QUESTION

SECTION - B

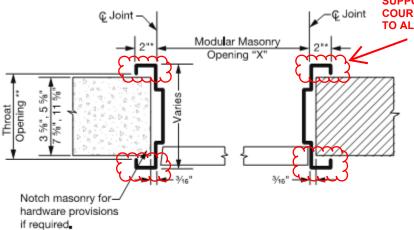
CAN A 16" LENGTH (i.e. FROM 24" ABOVE THE FLOOR TO 40" ABOVE THE FLOOR) OF THE PORTION OF THE DOOR FRAME THAT PROJECTS PAST THE CONCRETE BLOCK WALL FACE BE CUT OUT, AND THEN LATER WELDED BACK AND GROUND FLUSH?

REASON: SO THAT A HORIZONTAL STEEL CHANNEL CAN BE BOLTED TO THE BLOCK WALL TEMPORARILY TO SUPPORT IT WHILE TWO BOTTOM BLOCK COURSES ARE TEMPORARILY REMOVED TO ALLOW REPAIR OF THE FLOOR.
